RFB No. 20-010

Camp John Hope Road Bridge Maintenance and Repair

PURPOSE: The purpose of this addendum is to address questions submitted by potential bidders.

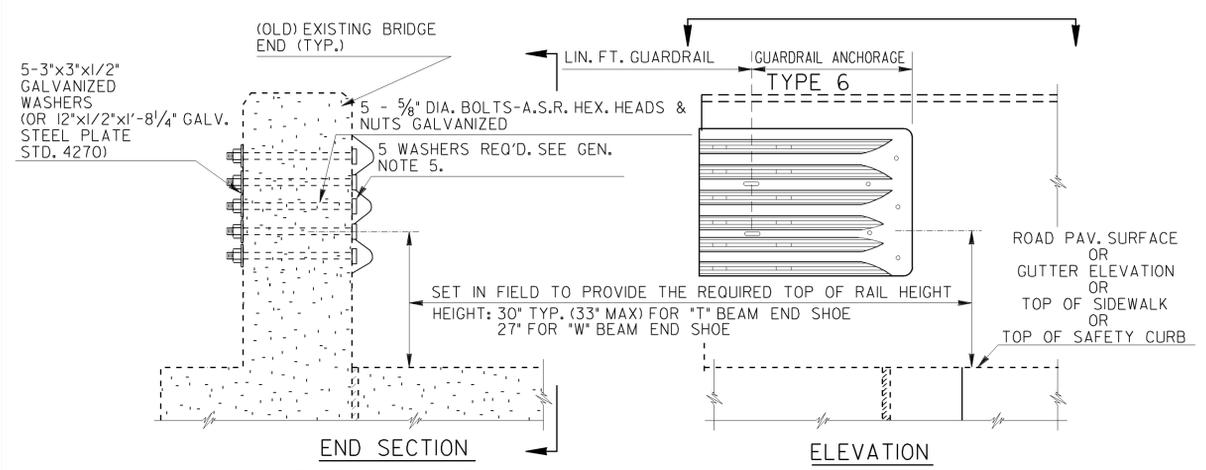
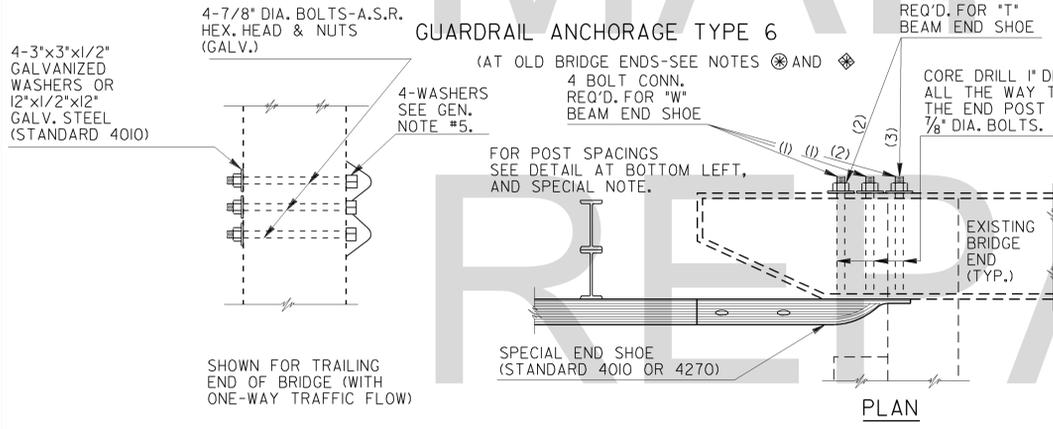
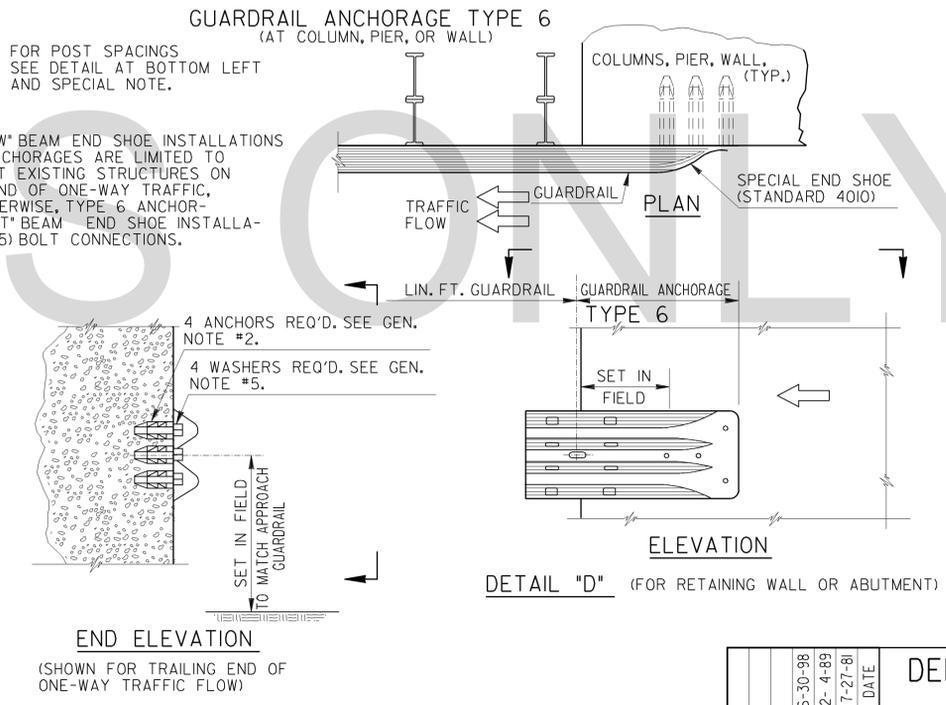
4. Question: Note #1 on page 3.0 of the plans refers to GDOT Std. 4382 in reference to the attachment of the guardrail to the existing bridge. This standard is for the use of the current GDOT standard straight end post at the end of a bridge, however, the existing bridge has radial end posts. The guardrail shoe that is shown on the GDOT Std. is not compatible with the radial type of end post. Please address and advise.
Answer: See attached GDOT Std. 4013. The standard has been removed from current GDOT standards for construction and is to be used for maintenance. Replace GDOT Std. 4382 with the attached GDOT Std. 4013.
